Office Action Summary	Application No. 10/025,903	Applicant(s) MOON, KYO HO	
	Examiner John M. Parker	Art Unit 2823

DETAILED ACTION

Claims 1-15 are rejected under 35 U.S.C. 102(b) as being anticipated by applicant's admitted prior art (AAPA).

Fig. 2

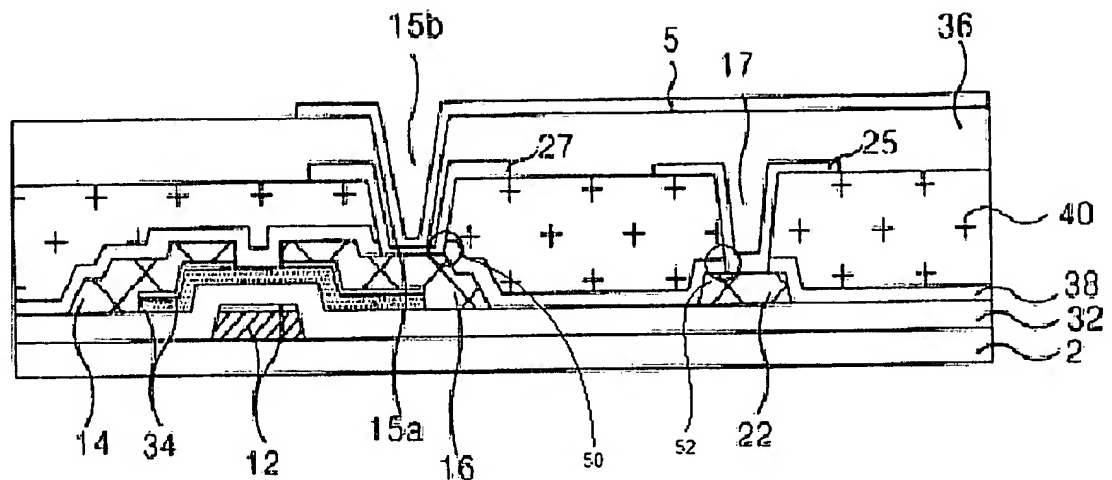
Regarding claim 1, Fig. 2 of AAPA teaches an X-ray detecting device, comprising:

a thin film transistor having a gate electrode [12], a source electrode [14] and a drain electrode [16] provided on a substrate;

a first protective film covering the thin film transistor [38];

a first drain contact hole passing through the first protective film [50];

a second protective film provided on the first protective film [40];

a second drain contact hole passing through the second protective film centering around the drain contact hole [15b]; and

a transparent electrode connected to the drain electrode via the first and second drain contact holes [27, pg. 5, paragraph [0012] confirms it is indeed transparent].

Regarding claim 3, Fig. 2 of AAPA teaches the X-ray detecting device according to claim 1, further comprising: a ground line having the lower electrode of a storage capacitor on the substrate [22];

a first storage contact hole passing through the first protective film covering the ground line [52];

a second storage contact hole passing through the second protective film centering around the first storage contact hole [17];

and a storage electrode electrically connected to the ground line via the first and second storage contact holes [25].

Regarding claim 6, Fig. 2 of AAPA discloses the X-ray detecting device according to claim 5, further comprising: a third protective film provided on the second protective film [36]; and

a pixel electrode electrically connected to the drain electrode via a contact hole passing through the third protective film [5].

Regarding claim 7, Fig. 2 of AAPA teaches the X-ray detecting device according to claim 3, further comprising: a third protective film provided on the second protective film [36]; and

a pixel electrode electrically connected to the drain electrode via a contact hole passing through the third protective film [5].

Regarding claim 9, Fig. 2 of AAPA teaches a method of fabricating an X-ray detecting device, comprising the steps of:

providing a gate electrode on a substrate [12];

providing a gate insulating film on the substrate [32];

providing a semiconductor layer on the gate insulating film [34];

providing a source electrode [14] and a drain electrode [16] on the gate insulating film;

providing a first protective film on the gate insulating film [38];

providing a first drain contact hole passing through the first protective film [50];

providing a second protective film on the first protective film [40];

providing a second drain contact hole passing through the second protective film centering around the first drain contact hole [15b]; and

providing a transparent electrode on the second protective film [27, pg. 5, paragraph [0012] confirms it is indeed transparent].

forming a first storage contact hole passing through the first protective film covering the ground line [fig. 2, 52];

forming a second storage contact hole passing through the second protective film centering around the first storage contact hole [fig. 2, 17]; and

forming a transparent electrode on the second protective film [fig. 2, 25, pg. 5, paragraph [0012] confirms it is indeed transparent].

forming a third protective film on the second protective film [fig. 2, 36]; and

forming a pixel electrode on the third protective film [fig. 2, 5].
